CITY OF ALBUQUERQUE

September 19, 2022

**Re: Nusenda Credit Union
2801 Juan Tabo NE
Conceptual Traffic Circulation Layout for DRB Approval
Engineer's Stamp 09-18-22 (H21-D020)**

1 site plan
A001 1"=20'

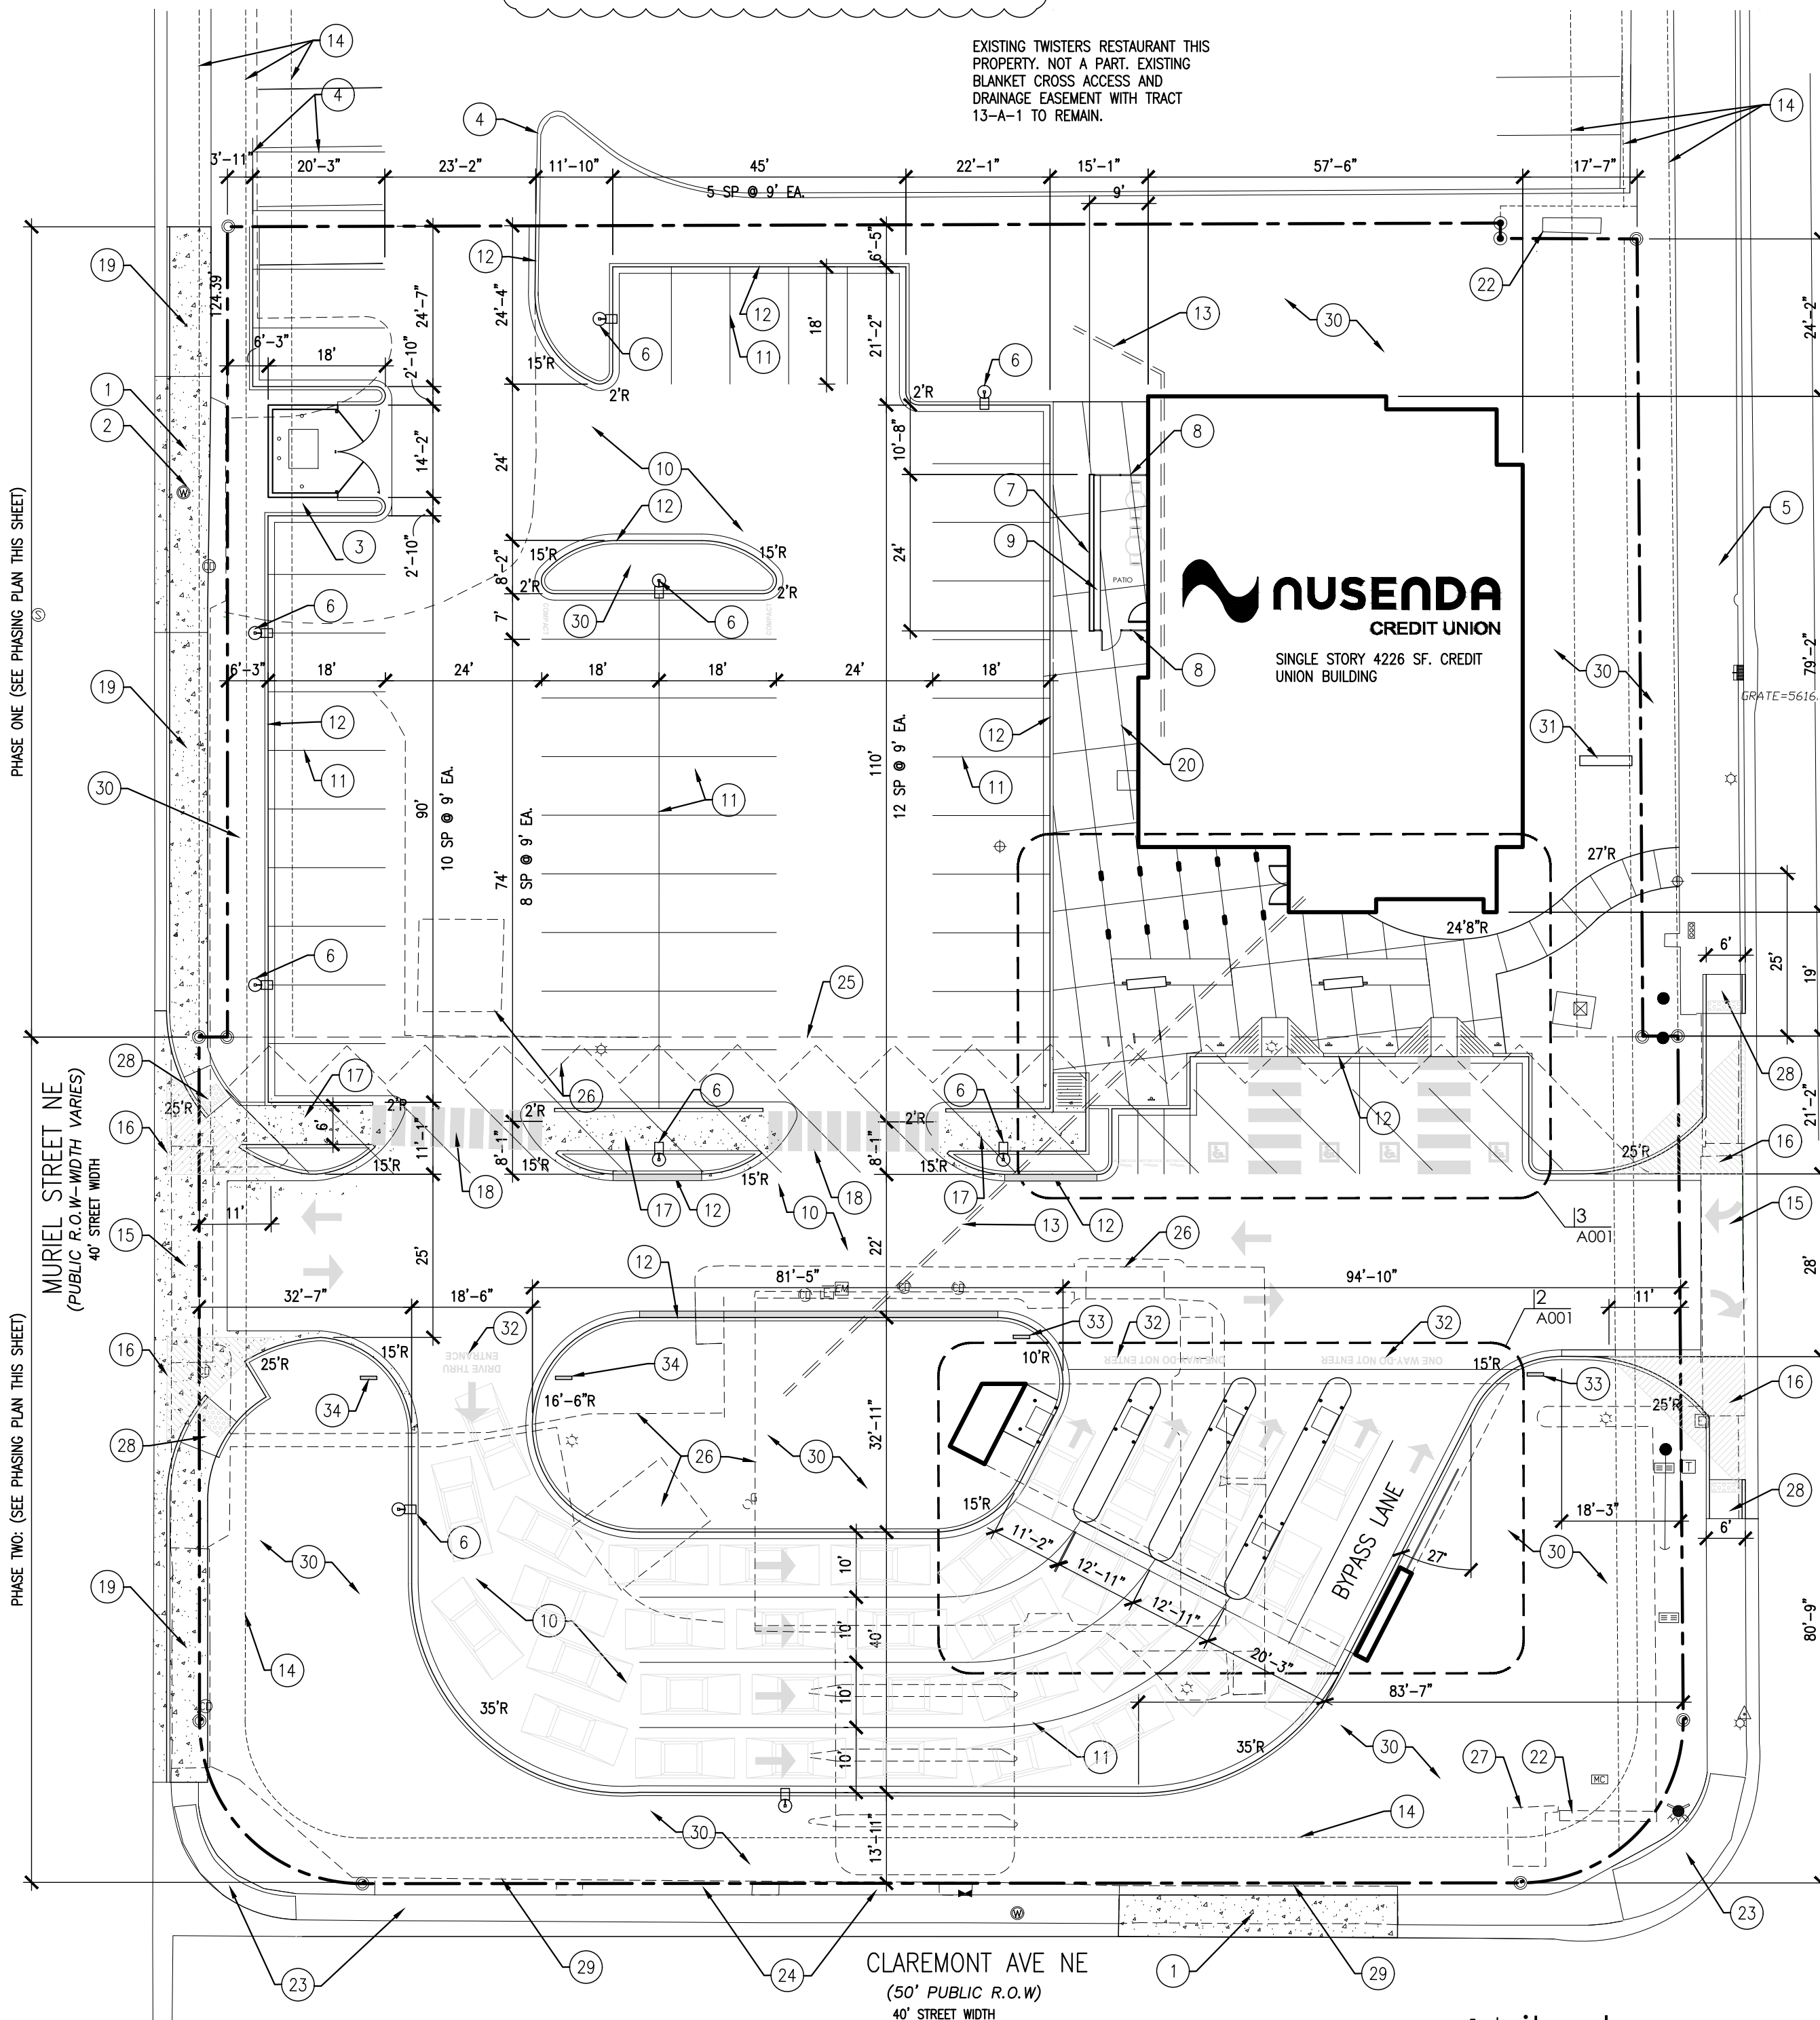
The conceptual TCL submittal received 09-06-2022 is approved for DRB submittal. When submitting this project through the building permit process, please provide a copy of the approved DRB Site plan along with a more detailed site plan for construction purposes through a second Traffic Circulation Layout submittal process. The detailed plan will be compared against the approved DRB site plan to ensure that all previously approved site infrastructure is shown with exact paving layout, dimensioning, and parking capacity. Ultimately, a copy of the approved DRB Site Plan and the more detailed stamped and signed plan will both be needed for each of the building permit plans. Please keep these originals to be used for certification of the site for final C.O. for Transportation. **Providing ADA ramps easement, is Conditional Release of final CO.**
